ADDENDUM #5

RFQ #7549049
TITLE: PORTSMOUTH MAINTENANCE FACILITY
SUBMISSION DEADLINE: 1/22/15 – 11:00 a.m.

STATE OF RHODE ISLAND DEPARTMENT
OF TRANSPORTATION
PROPOSED MAINTENANCE FACILITY
BOYDS LANE, PORTSMOUTH

SKE.02R

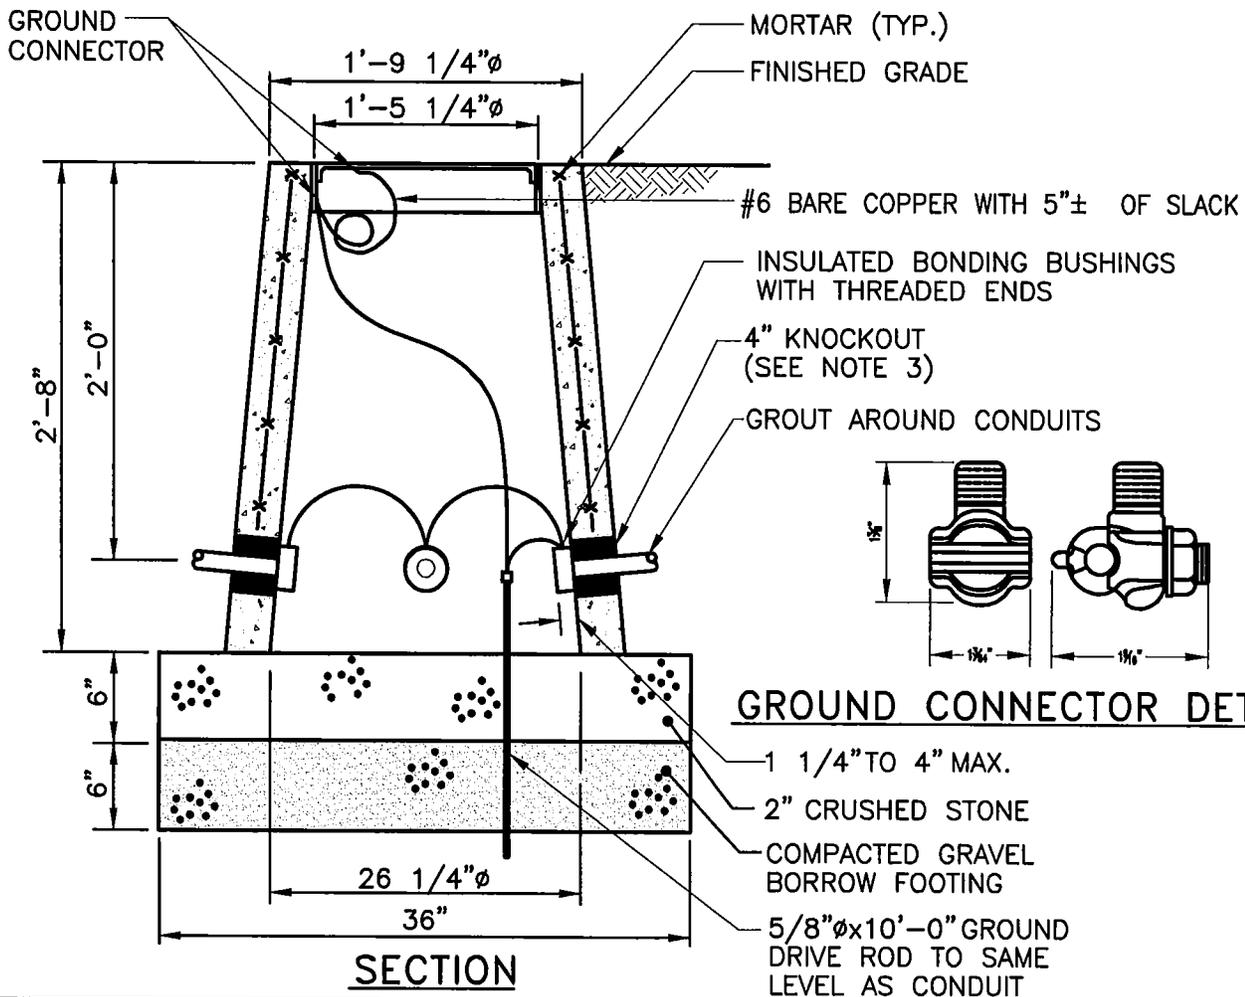
10. Add the following new sketches to the Project Documents:
SKE.02R Precast Type 'A' Handhole dated 02 May 2014.
SKE.05 Breakaway Support Couplings for Light Standards dated 02 May 2014

11. Delete the following sketches from the Project Documents:
- A. Addendum #2 dated 18 December 2014 item #22.C, Sketch SKE.02 is void. Replaced by SKE.02R issued this addendum.

SKE.05

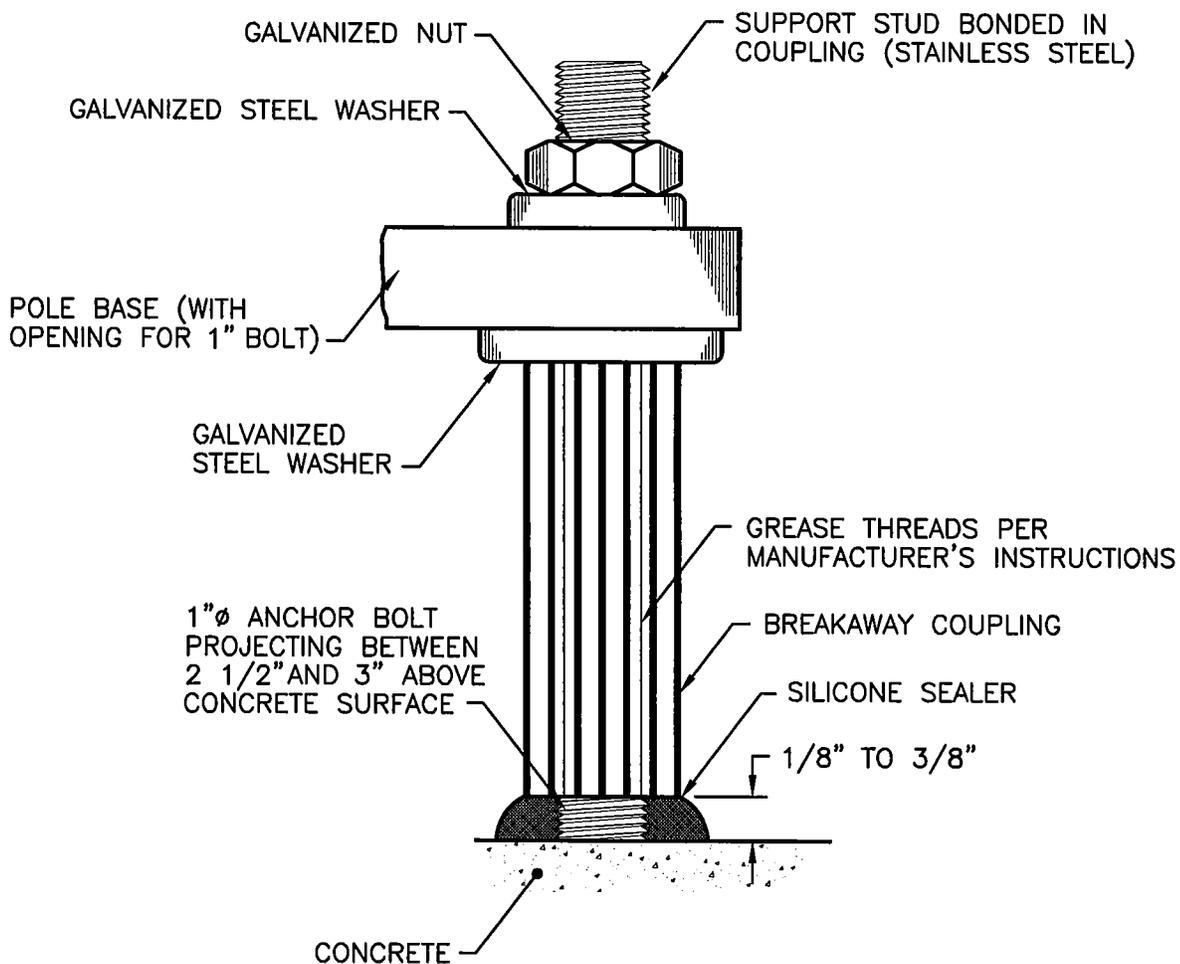
8. E100
- A. Add: At each site light Type 'G' pole, provide light pole break away 'kits' per SKE.05.
- B. Clarification: Site lighting conduit size shall be 2" schedule 40 PVC. Concrete encase conduit under paved areas.
